NSVR - Control Board

TITLE: NS_ARM_Control_01_10_2018

USB/PROGRAM/DEBUG/UART

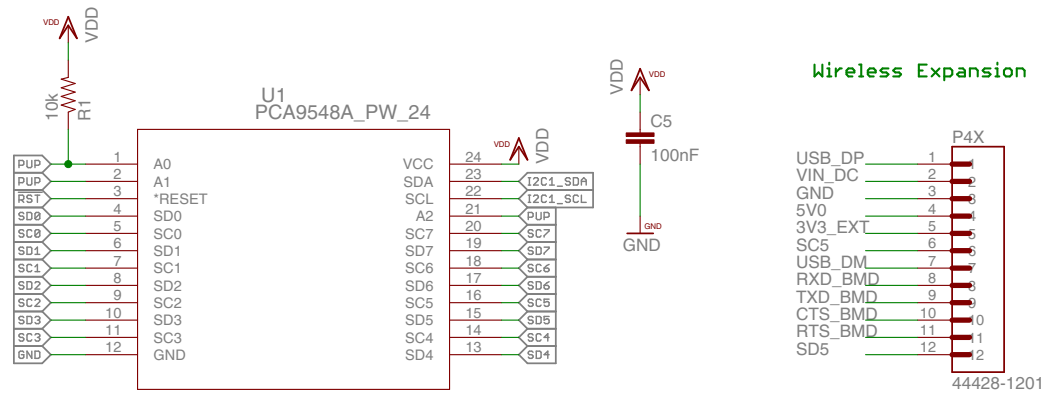
There are no pullup resistors on the downstream hub lines---
You are depending on having them on the downstream devices!
